BOARD OF WATER SUPPLY

Subject: Honolulu Board of Water Supply Comments on Navy's "AOC SOW Section 5 Corrosion and Metal Fatigue Practices, Destructive Testing Results Report" dated July 7, 2019 and IMR's Report "Destructive Analysis of 10 Steel Coupons Removed from Red Hill Fuel Storage Tank #14" dated December 17, 2018

Figure 2-1 Schematic of Tank 14 Coupon Locations

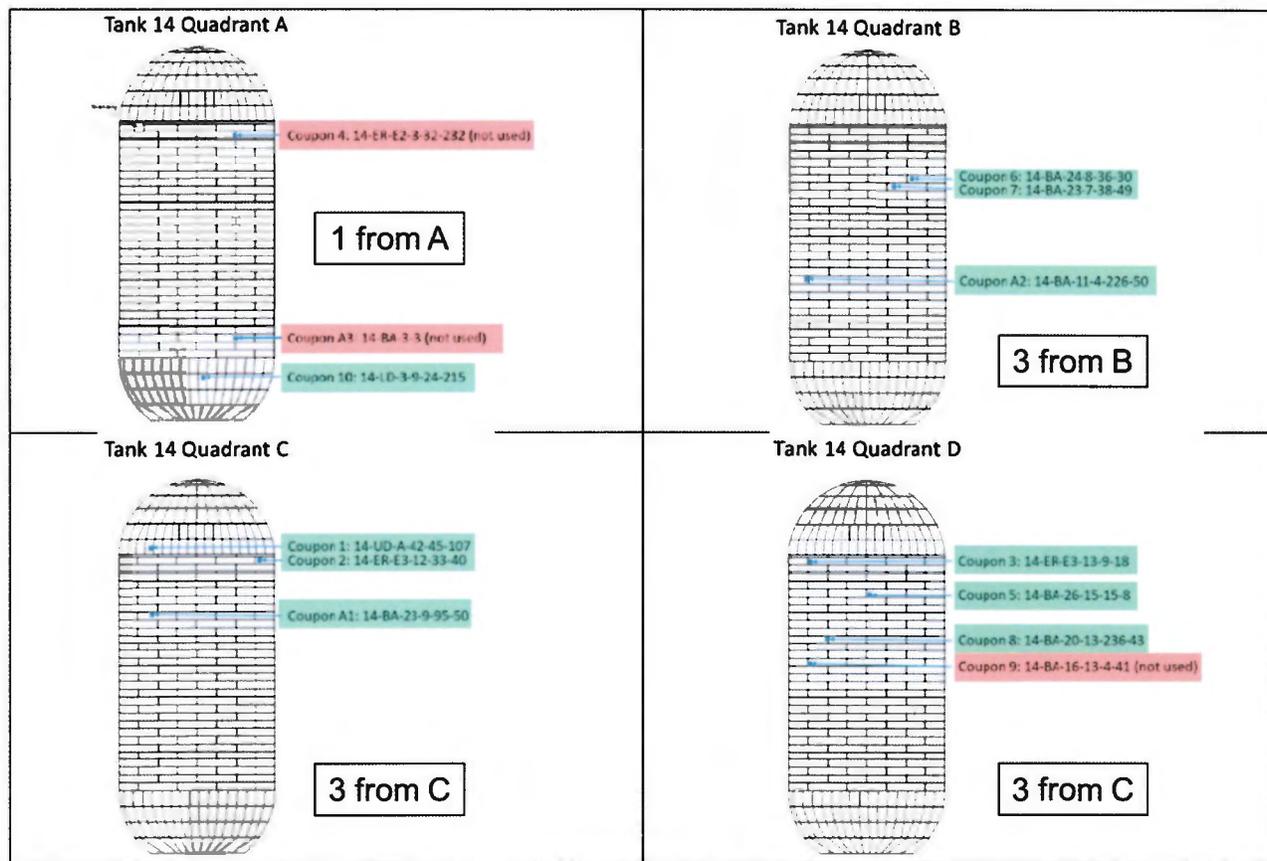
The Navy, however, did not follow its commitment in the DT SOW and instead selected a much less diverse range of coupons that are unlikely to be representative of the potential conditions

within Tank 14 much less the conditions of all the tanks at the RHBFSF. Ultimately, the Navy extracted eight coupons from the tank barrel (i.e., the vertical walls), one from just inside the upper dome, and one from sloped section of the lower dome; shown below for the locations marked in green. The locations marked in red were identified as possible coupon locations but were not extracted. The BWS is not aware of any random locations selected based on the BFET scans specifically to assess the welds. The Navy's description of the NDE result at these coupon locations do not discuss the BFET result at all. Further, the BWS is not aware of any coupons extracted from the lower dome bottom plate.

Figure 1 – Destructive Testing Cross-section from Sample 6-1

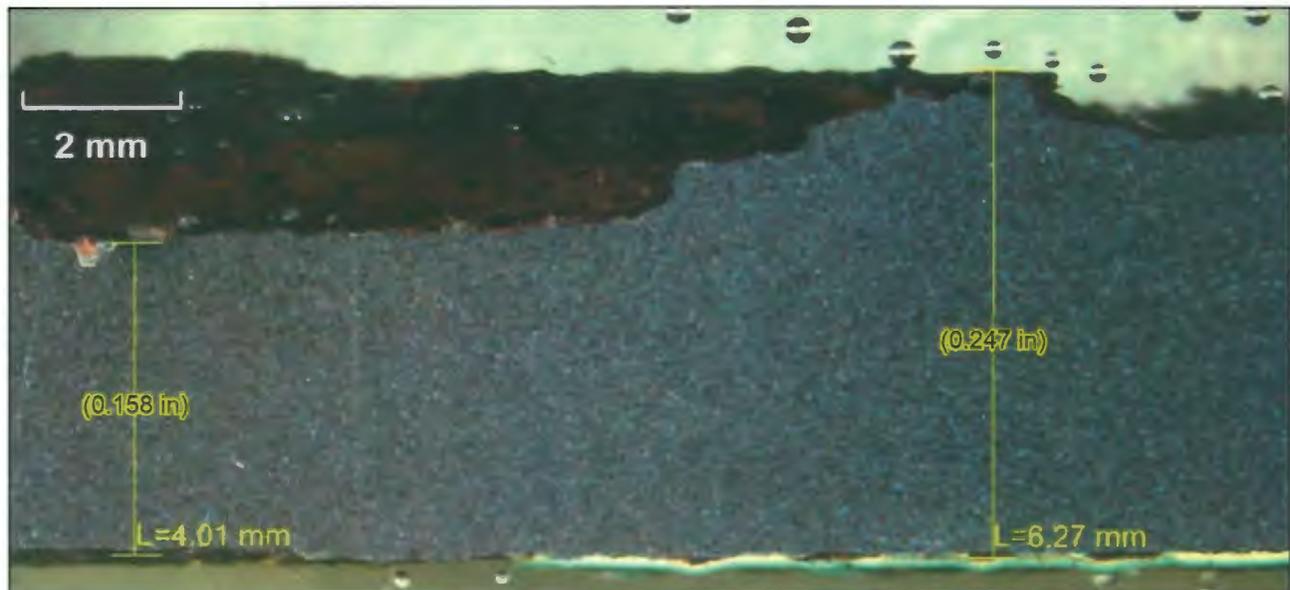
However, the BWS disagrees with both the DT report’s characterization of the corrosion pit identified at Coupon 6 and the significance of the inability of the LFET method to identify such a pit. First, both LFET methods as described in the Tank Inspection and Repair, and Maintenance (TIRM) Report (Navy, 2016b) should have detected the pitting found in Coupon 6. From the October 2016 TIRM Report, there were two LFET methods being considered:

1. The larger, TesTex Falcon Mark II 2000 device should have been able to detect the pit in Coupon 6. According to the Navy this device has a probability of detection (POD) of 100% at 25% wall loss on pits with an aspect ratio of 3:1. The deepest pit in Coupon 6 amounted to ~37% wall loss and aspect ratio of greater than 3:1 (width to depth ratio). Figure 1 shows the cross-section through the deepest pit in Coupon 6 where the size and depth of the pit is obvious.
2. The smaller, TesTex TS-2000 device should have been able to detect the pit in Coupon 6 as the Navy stated this device can detect pits with a diameter of 1.57 mm. The width of the corrosion pit in Coupon 6 was much, much wider than 1.57 mm as is shown in Figure 1.

Second, the BWS believes Figure 1 clearly demonstrates this pit cannot be described as a “*pit of very small volume.*” This figure clearly shows a broad pit of considerable volume.

A similar figure was provided for Coupon 6 in Figure 1. The Navy's LFET and PAUT entirely missed the backside corrosion on Coupon 6, but the DT showed the minimum wall to be 0.158 inches thick. That is, DT demonstrated that this location should have been repaired, whereas both the LFET and PAUT NDE techniques indicated that the liner in this area was thicker than 0.200 inches.

Figure 2 -- (Image from: IMR Test Labs. 2018)

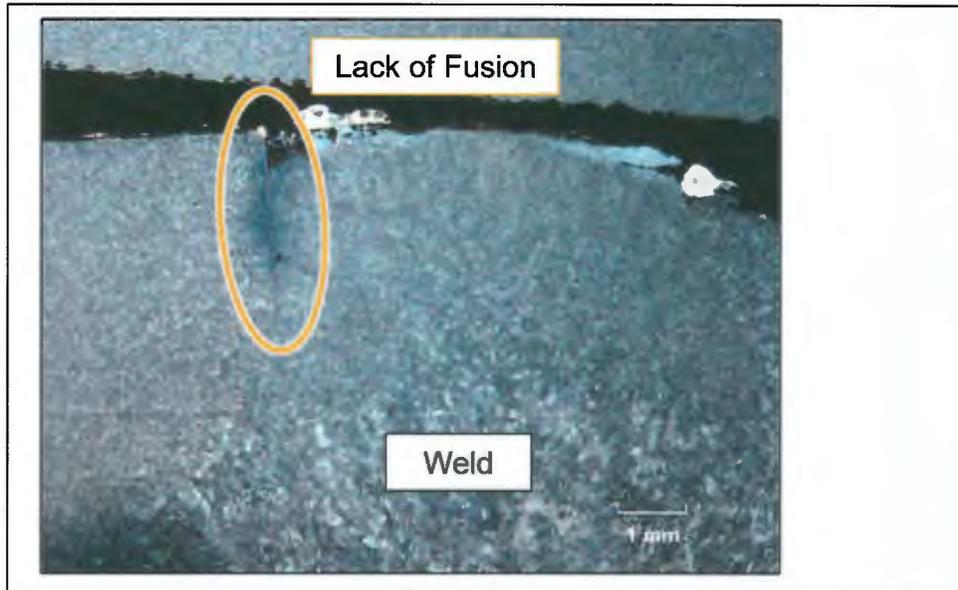
4. The DT inspection did find weld defects. The one coupon that actually had a weld contained a linear defect that was found by destructive testing. This lack of fusion linear weld defect is shown below.

Figure 4 – Relationship between NDE thickness estimate prior to DT and the actual remaining thickness determined from DT.

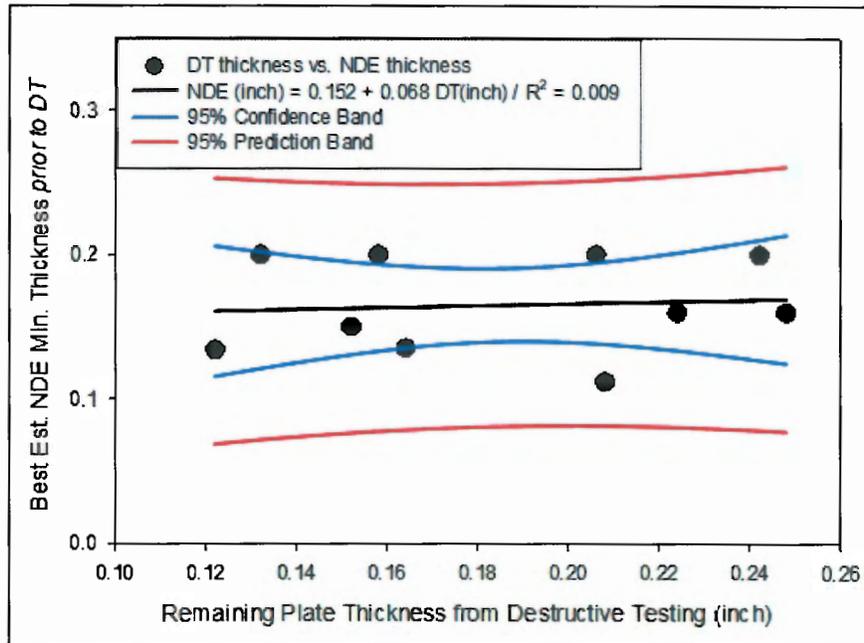
Figure 4 clearly indicates the NDE techniques are neither accurate nor reliable. First, the slope (0.068) of the line drawn through the DT vs NDE data is very flat (close to zero), indicating the NDE results are essentially insensitive to actual corrosion depth. For comparison, if NDE was perfectly accurate, then the DT thickness would be equal to the NDE thickness and the slope of the line drawn through the data would be 1.0. Instead, the calculated slope is consistent with what one would expect if the NDE results were simply chosen at random without regard to the actual coupon thickness. Another indication is the coefficient of determination (R^2), which measures NDE accuracy by comparing the variation in NDE results to the residual variation after accounting for the actual coupon thickness (using the regression line). As noted in Figure 4, the R^2 value is effectively zero (0.009), indicating none of the observed variation in NDE-measured thickness is attributable to corresponding variation in the actual thickness of the test coupons.

Finally, the figure includes plots of the 95% lower and upper prediction bands, which are very broad. For example, for a coupon with an actual remaining wall thickness of 0.12 inch, with 95% probability the corresponding NDE-measured thickness will fall between 0.070 and 0.25 inch (the values at which the lower and upper bands, respectively, intersect the vertical line at 0.12 inch). The bands vary little over the range of coupon thickness studied. Thus, for any actual tank wall thickness, the NDE-measured thickness can be reasonably expected to range from effectively no damage to severe damage.

Figure 5 – Destructive Testing Cross-section from Sample 3-3.

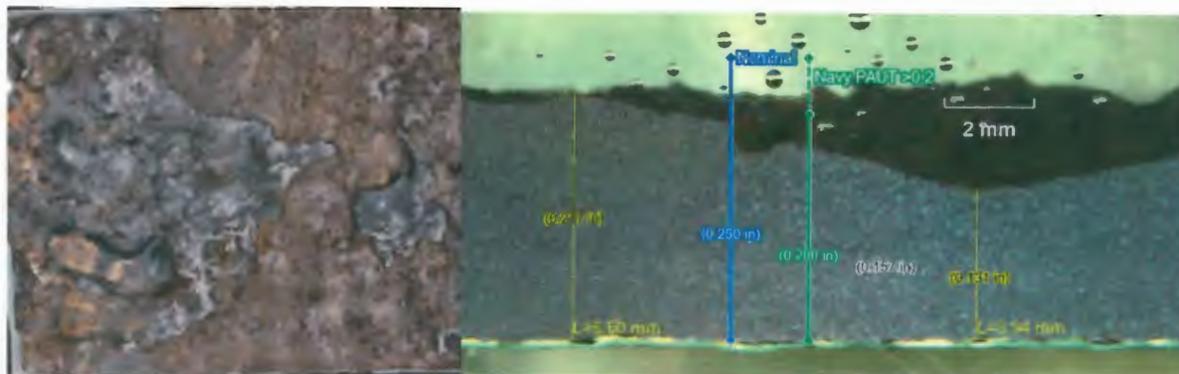
A more graphic illustration of the error in the NDE methodology is shown in Figure 5. The image on the left-hand side of Figure 5 shows the extensive backside corrosion on Coupon 3. The right-hand side of Figure 5 shows the plate's reported thinnest area in cross-section after destructively testing. While it is unclear from the DT and IMR reports, this thinned region

(0.131-inch-thick) was presumably located by CT scanning of the entire coupon. The Navy NDE predicted that this area had little to no backside corrosion.

The thin blue-green layer on the bottom of the plate on the right-hand side of Figure 5 is the paint on the fuel wetted side of the steel liner. The blue line shows the full plate thickness of 0.250 inches. The yellow line on the left side is the actual maximum plate thickness which shows 0.217 inches thickness indicating general corrosion thinning and deeper corrosion over the back side of this steel coupon. The green line shows the thickness the PAUT found, i.e., > 0.200 inches (LFET found a remaining wall of 0.033 inches but the supposedly more accurate PAUT indicated the plate was much thicker). The actual minimum thickness found by DT was 0.131-inches as shown by the yellow line on the right side. This variation in the lengths of the colored lines illustrates how large the difference can be between the various NDE inspection techniques and the actual depth of corrosion. In this case, LFET indicated the plate was very thin, the PAUT prove-up indicated little-to-no corrosion, and the DT indicated that this location was sufficiently thinned that repair should have been triggered.
